Groundwater Application Review Summary Form

Application # G- 19324

TO: Water Rights Section Date 7/11/2023
 FROM: Groundwater Section Jen Woody
 Reviewer's Name
 SUBJECT: Application G- 19324 Supersedes review of n/a
 Date of Review(s)

A. GENERAL INFORMATION: Applicant's Name: Milton Freewater Cemetery Maintenance County: Umatilla

Figure 3. Water-Level Measurements in Nearby Wells

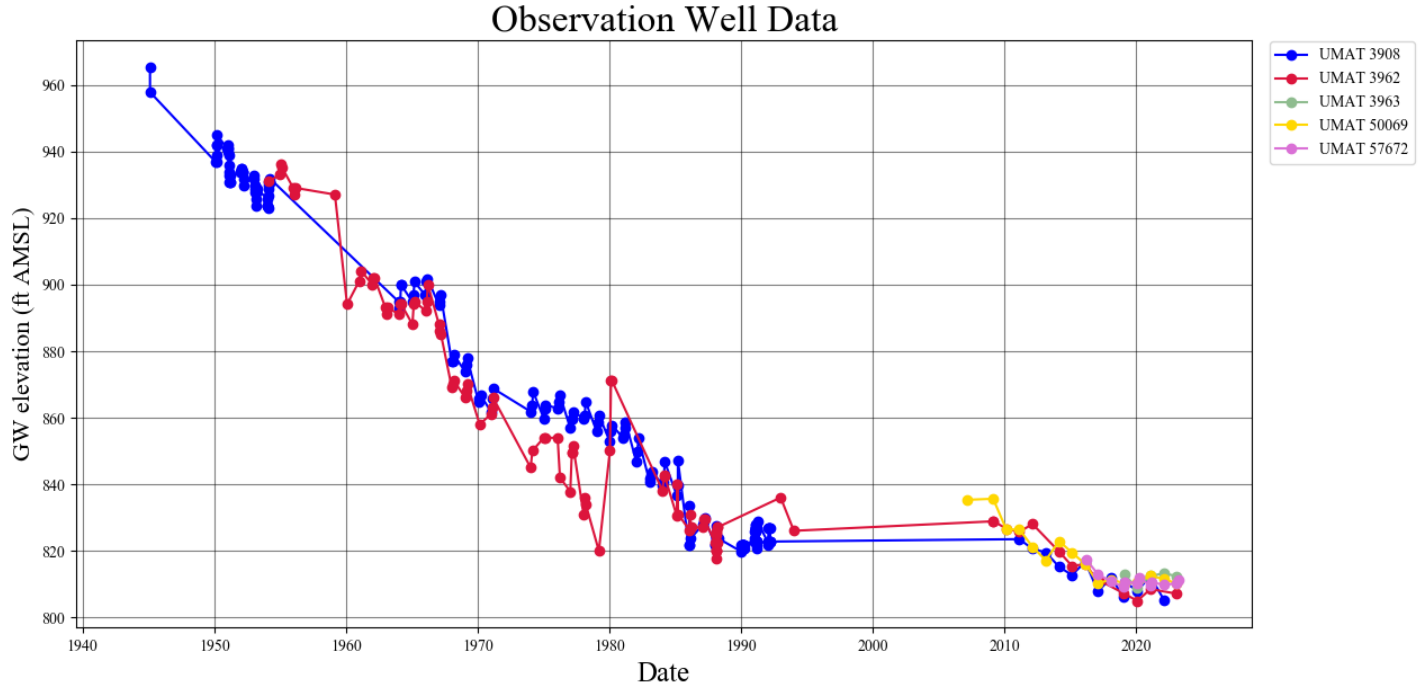
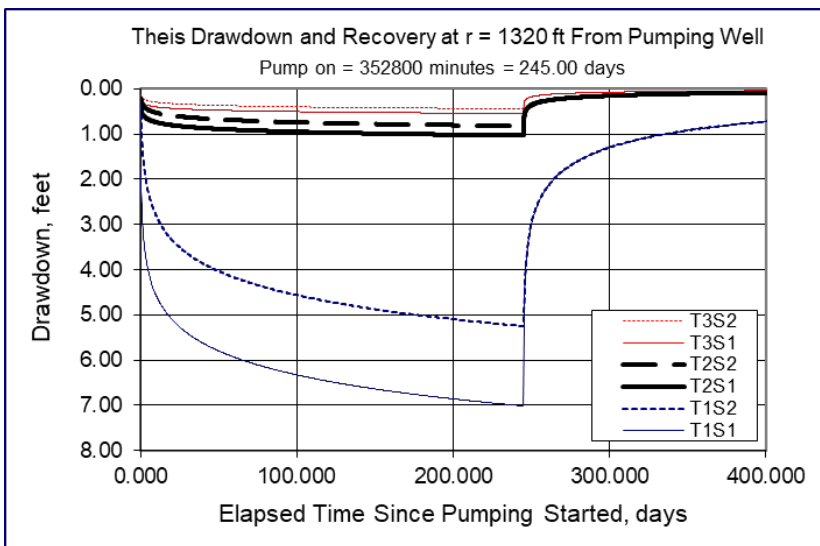
As shown in Figure 3, groundwater level trends in nearby wells that access the same groundwater source as the proposed POA meet the definition of declined excessively per OAR 690-008-0001(4)(d) meaning total water level declines in the aquifer exceed 50 feet over the period of record. The groundwater level has declined approximately 90 feet since 1945, leading to the findings in B1a and B1c.
